A G E N D A

Architectural Review Board

September 25, 2018

1265 South Lawrence Street

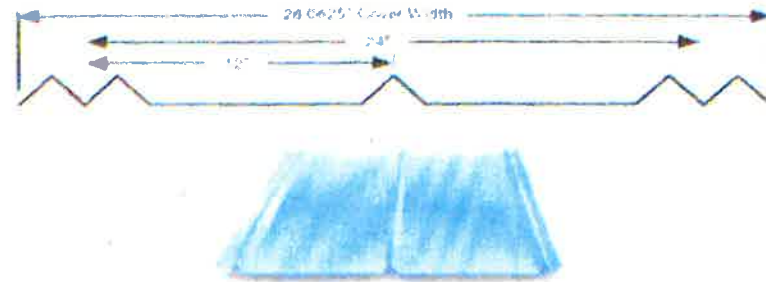
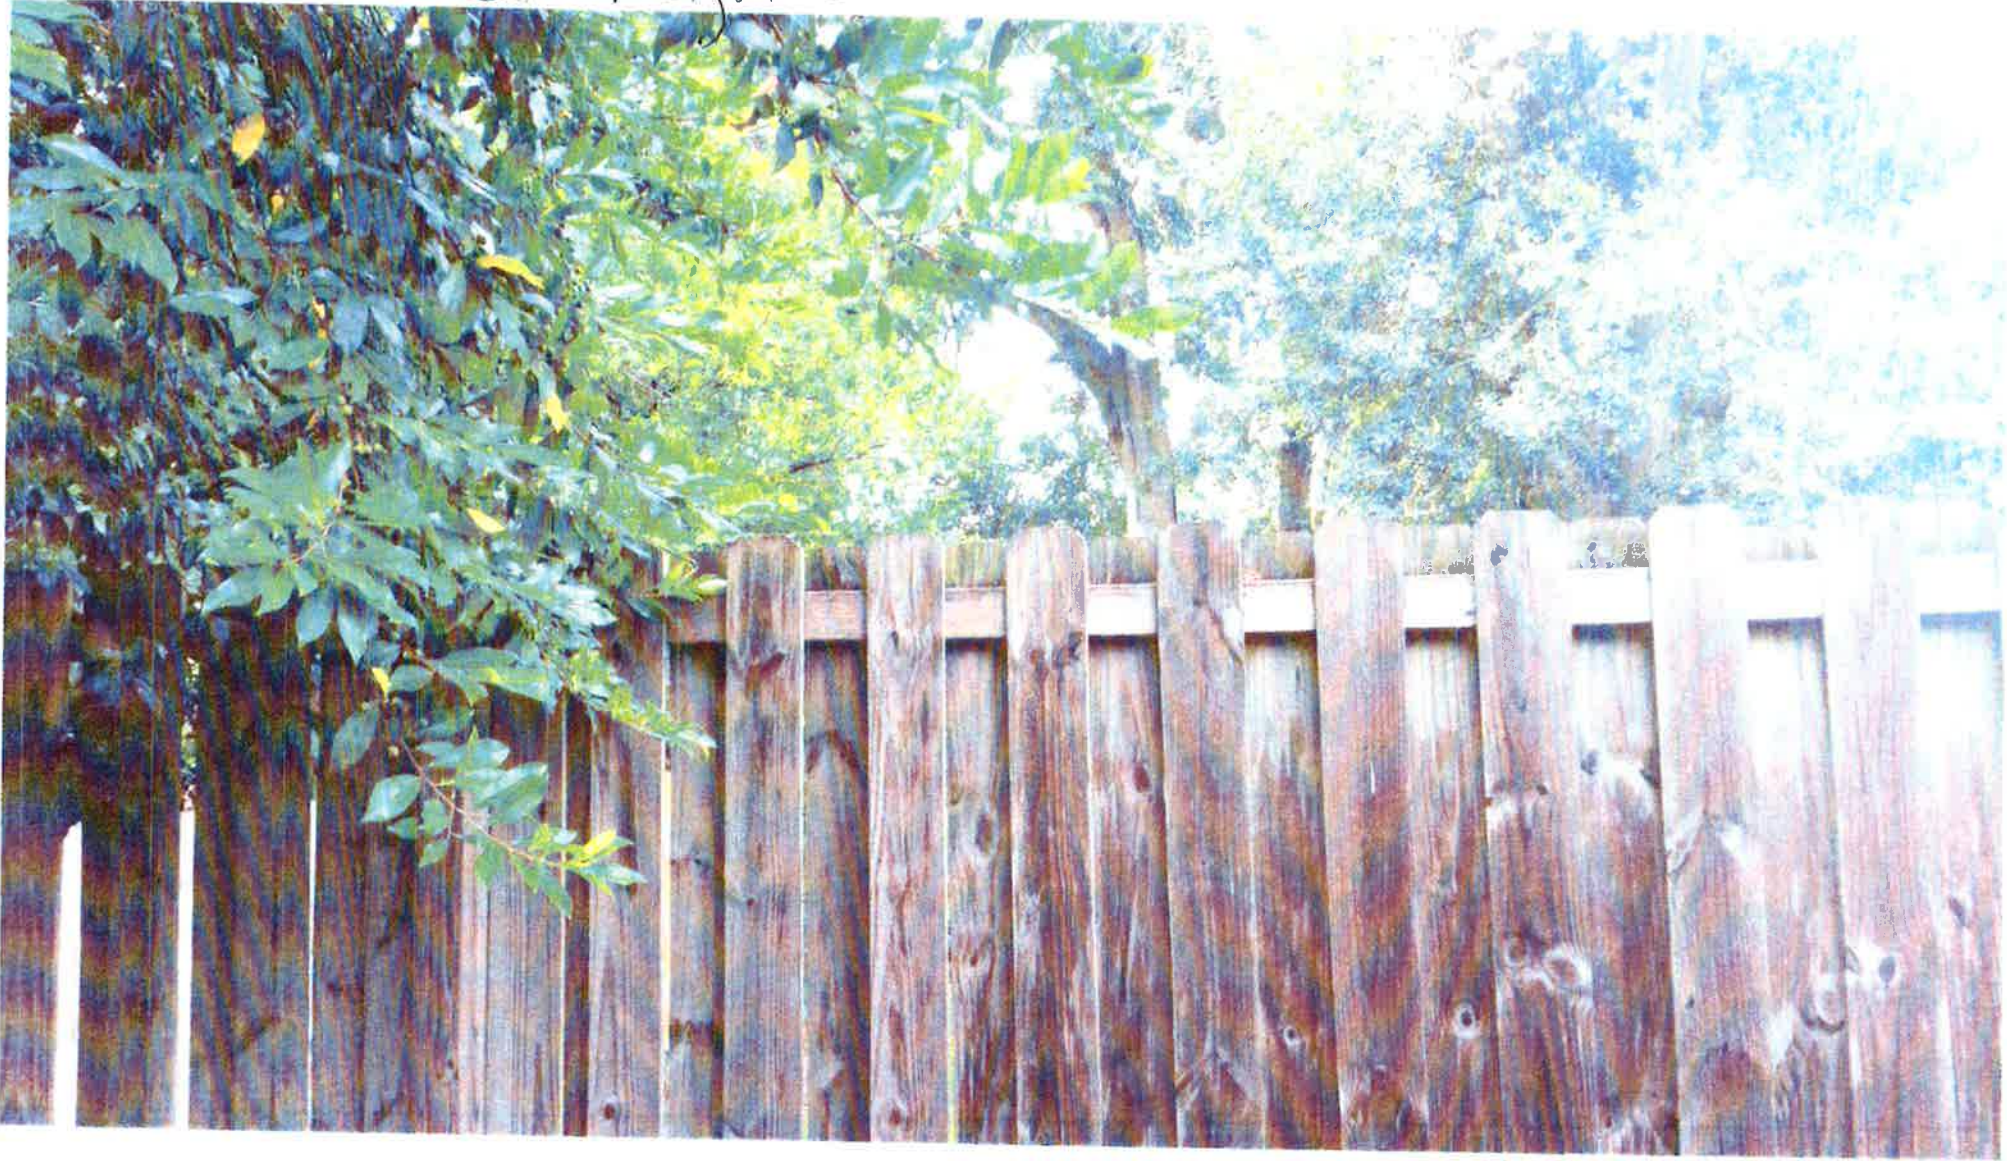
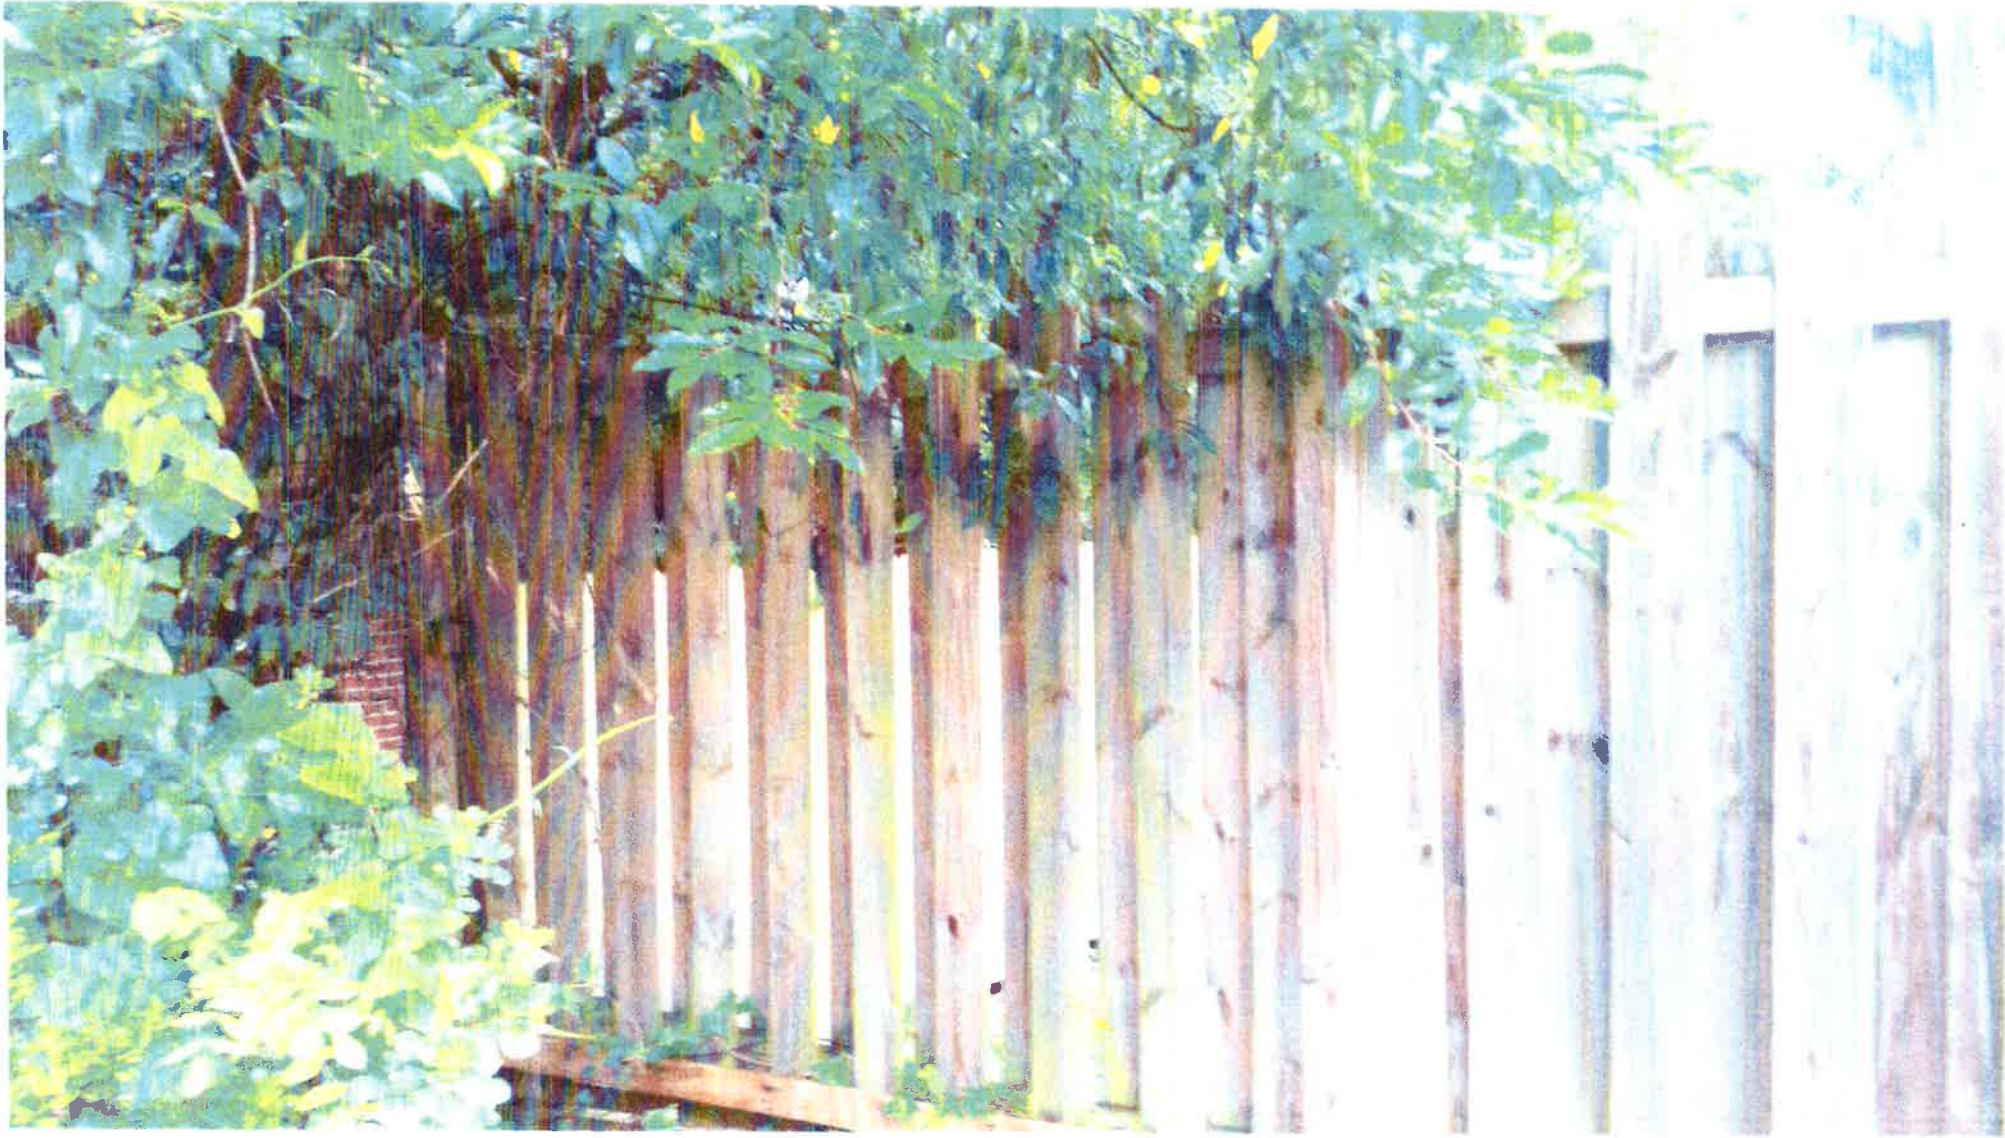
- The Board has approved metal roofs on outbuildings, and Burnished Slate (a dark brown/gray) has been one of the more common colors.
- Privacy fences have routinely been approved in rear yards.

1343/1347 Felder Avenue

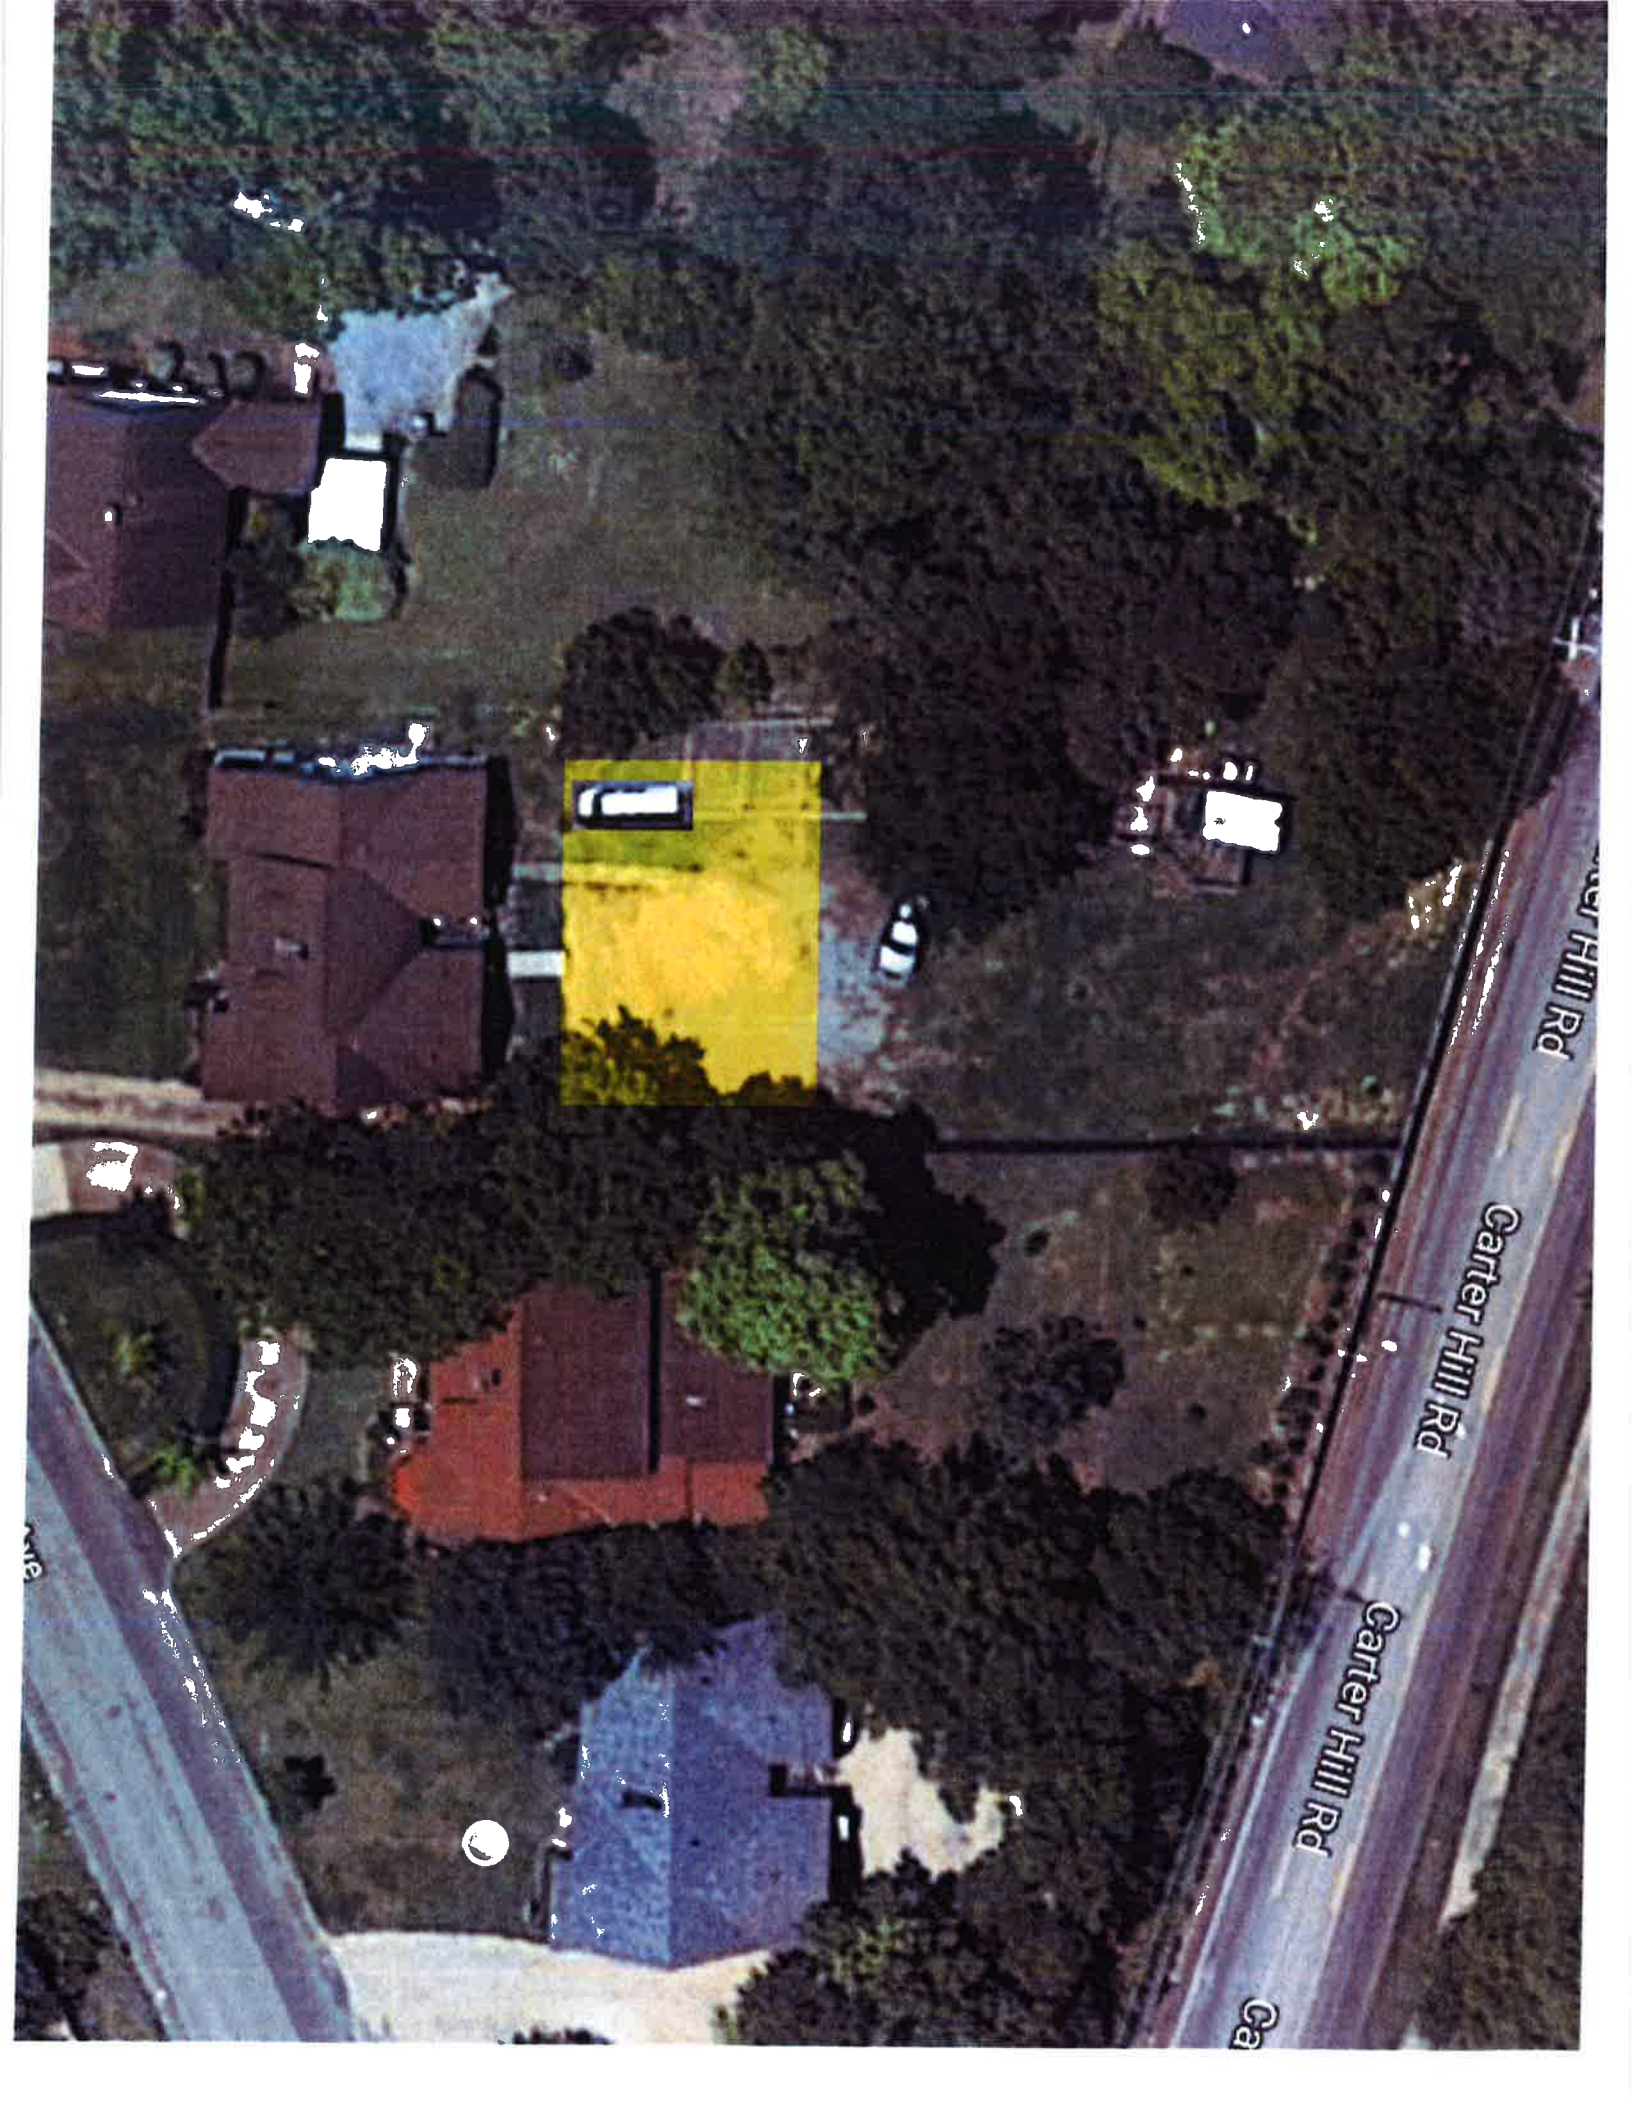
- The Board has approved gravel parking areas as long as they have some sort of boundary/edge that will keep the gravel contained. Parking in the rear is always preferable to parking in the front yard.
- The metal railing is an inconspicuous option for the porch.
